STAFF REPORT KETCHUM PLANNING AND ZONING COMMISSION REGULAR MEETING OF SEPTEMBER 9, 2019

PROJECT: Hammond House

APPLICATION TYPES: Mountain Overlay Design Review, Variance Request, Conditional Use Permit

FILE NUMBER: P19-021, P19-081, and P19-082

Figure 1 – Site Location and Red or High Avalanche Hazard Zone Map source: Caltopo.com, Wilson 1977, Mears, 1978

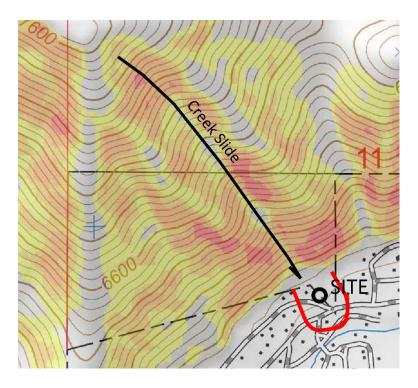
The Creek Slide avalanche path shown in Figure 1 lies in the city of Ketchum "Avalanche Overlay Zone". Figure 1 also shows the site and approximate "Red" or "High" Avalanche Hazard Zone mapped in separate studies by avalanche consultant Norman A. Wilson in 1977, and avalanche control engineer Art Mears, P.E. in 1978. The Red Zone is defined by high frequency or high impact criteria. The site exceeds both criteria thresholds. We estimate avalanche frequency at the site is about triple the Red Zone criteria and the impact pressures at the site exceed the Red criteria by a factor of five. Most jurisdictions in the United States prohibit residential development in Red Zones. The city of Ketchum allows development subject to conditions, including structural designs for avalanche impact and preventing avalanche diversions that increase the hazard to off-site lands and properties. The city of Ketchum attempts to protect residents and visitors, including delivery personnel and first responders, from avalanches with warnings and road closures during periods of high avalanche danger.

Figure 4 - North Wall

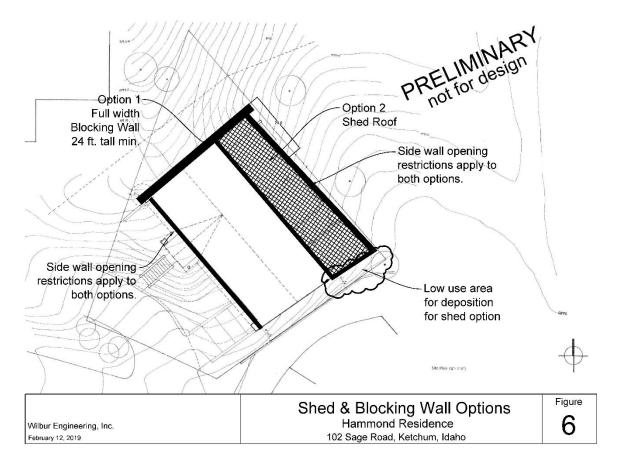
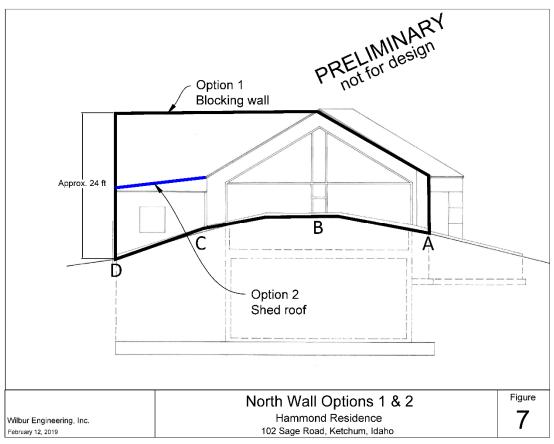
The current design for the uphill side of the planned Hammond residence is shown in Figure 4. It is primarily a blocking wall design, but the roof and east side patio will be overtopped and avalanche debris will fill the patio area and act on the east walls. Due to the frequency of avalanches at the site, the patio design must be modified to protect the outdoor living space and the east wall. This can be accomplished with either a shed roof, or by extending the blocking wall and modifying the east side openings.

Figure 5 – Garage Area

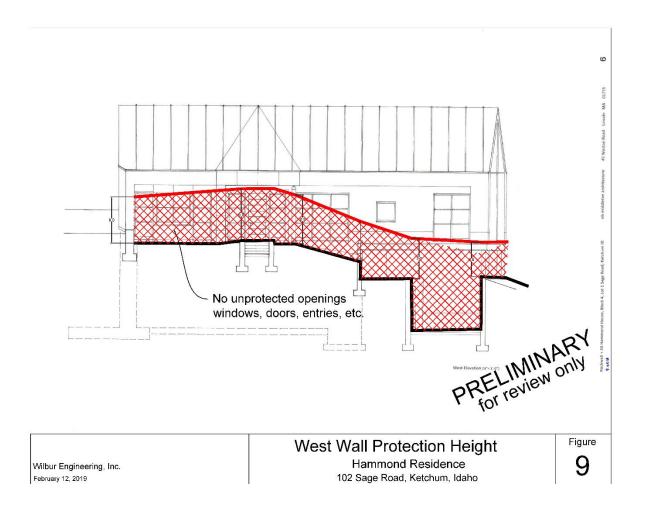
Figure 5 shows the garage area, which will accumulate significant deposits of avalanche debris. Persons in this area will not be protected during the design avalanche. Also, avalanche debris will block egress in this area.
